**\*MANDATORY SERVICE BULLETIN\*****NUMBER:** SB12-02**REVISION:** 01**DATE:** April 24, 2013

**SUBJECT:** COCKPIT FLOOR ACCESS PANEL INSTALLATION

KODIAK 100 Series Aircraft Serial Numbers: 100-001 through 100-0057

Document #:	Revision:	Document Title:
FSI-030	01	COCKPIT FLOOR ACCESS PANEL INSTALLATION

**Figure 3-1: Floor Panel Identification**

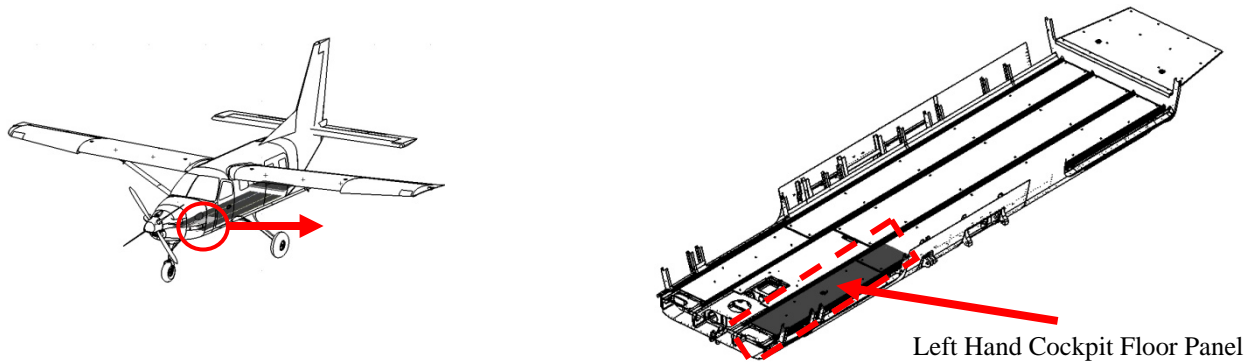
3. If equipped, remove any carpet installed over the left hand cockpit floor panel shown in **Figure 3-1**.
4. Remove the left hand cockpit floor panel (P/N 100-770-1000 or 100-770-1010) shown in **Figure 3-1** by removing the rudder gust lock and hardware, as well as the eight (8) screws securing the panel into position.

Figure 5-1: Nut Plate Removal

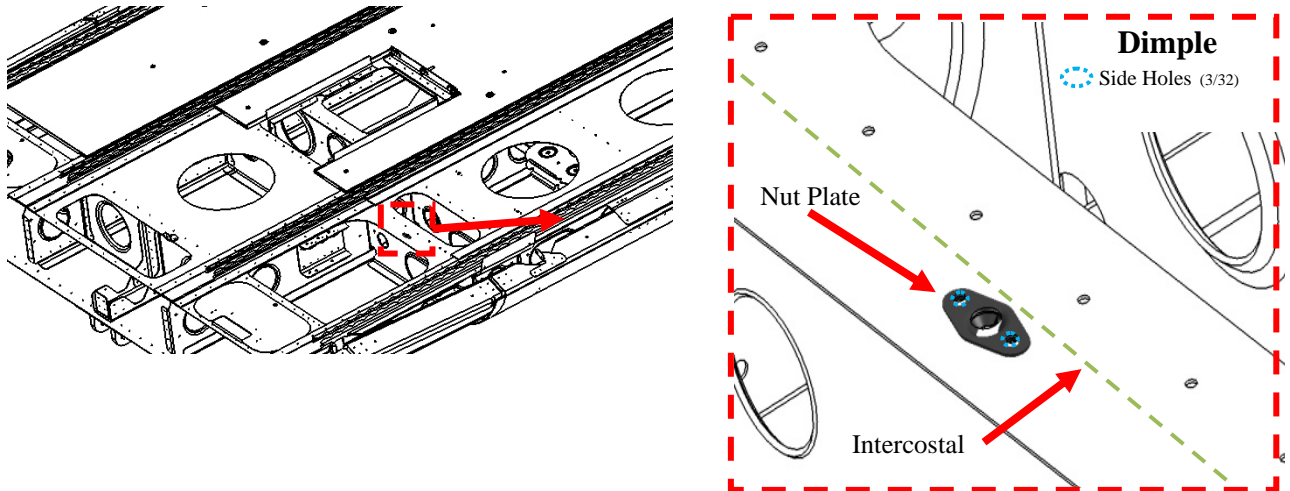
1. Remove the nut plate indicated in **Figure 5-1** by drilling out the rivets using a #40 drill bit.
2. Deburr the two side holes indicated in **Figure 5-1**.

1. Using a 3/32 dimple set, dimple the subfloor in the locations where the two (2) MS20426AD3-5 countersunk fasteners will be installed, as indicated in **Figure 5-1**.

- Using the two (2) NAS1097AD3-4 100° flush shear head rivets, install the new countersunk nut plate (P/N A6162-8Z1D) into the same location as the nut plate removed in **Section 5.2, Step #1**. Proceed to **Section 5.4**.

Figure 5-2: Floor Panel Modification

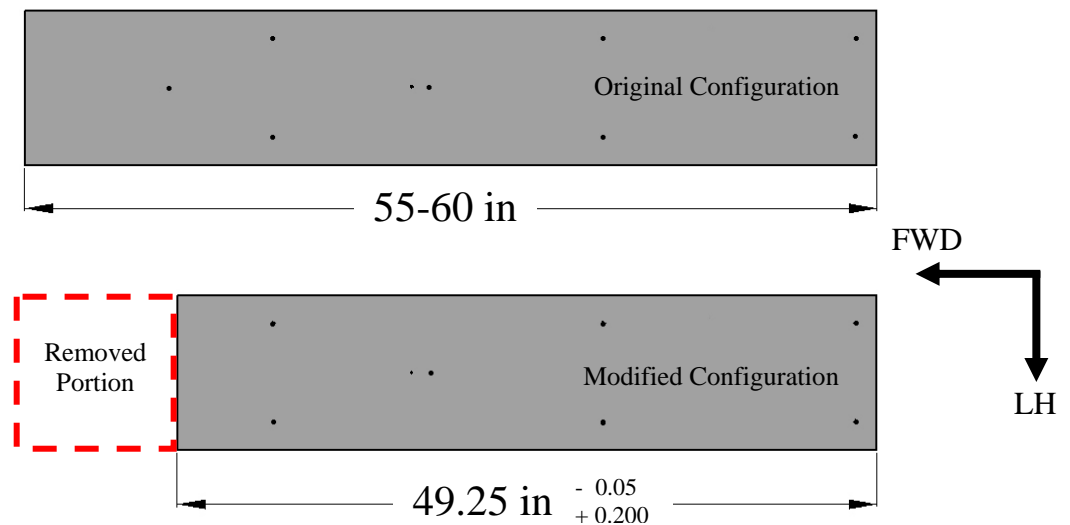
The left hand cockpit floor panel must be modified in order to provide clearance for the installation of the new floor access cover.

- From the aft end of the floor panel, measure and mark the left hand cockpit floor panel as shown in **Figure 5-2**.

2. Cut the indicated area of the left hand cockpit floor panel, off of the fwd end of the cockpit floor panel, at the mark created in **Step #1** above.
3. Remove all burrs, and sand all sharp edges from the modified area of the floor panel.

**Figure 5-3: Floor Access Cover**

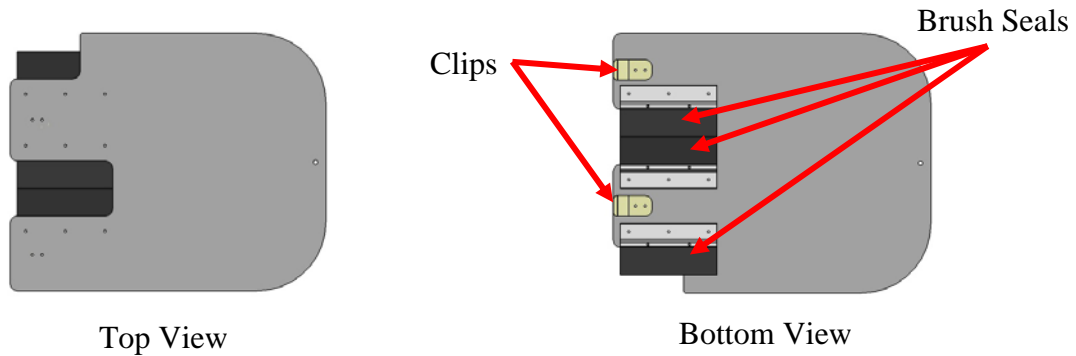
The floor access cover (P/N 100-270-3560) is designed with brush seals that closely fit around the rudder pedal arms, preventing sizeable foreign objects from falling into the subfloor area. The floor access cover is secured into position through the use of clips and a screw.

1. Position the floor access cover (P/N 100-270-3560) around the rudder pedal arms, ensuring that the clips on the bottom of the floor access cover are fully engaged, securing the front of the floor access cover. Using the new screw (P/N 8RX1/2THBSS), secure the aft end of the floor access cover.
2. Position and secure the left hand cockpit floor panel (P/N 100-770-1000 or 100-770-1010) using seven (7) of the screws removed in **Section 4.1 #4**, discarding the remaining screw. Position and secure the floor anchor using the bolt removed in **Section 4.1 #4**. Refer to **Figure 5-4**.

**Figure 5-4: Floor Panel Installation**

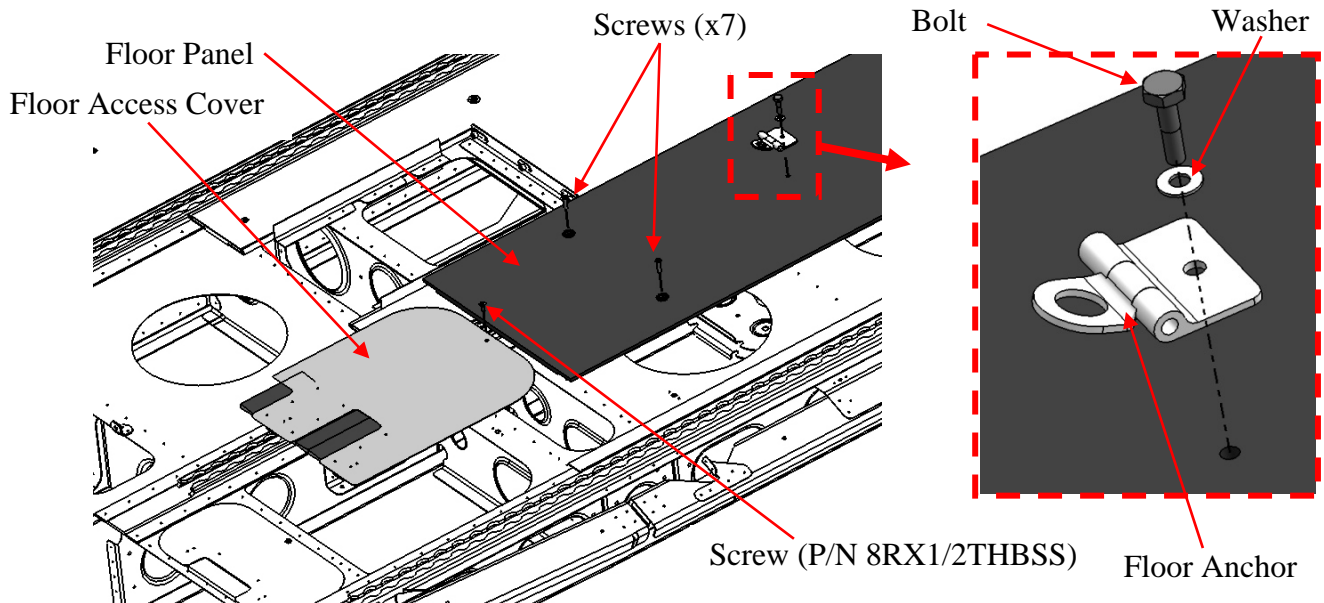
Over-tightening the bolt securing the floor anchor into position may cause damage to the subfloor skin of the aircraft. Tighten the floor anchor bolt to snug + ½ turn.
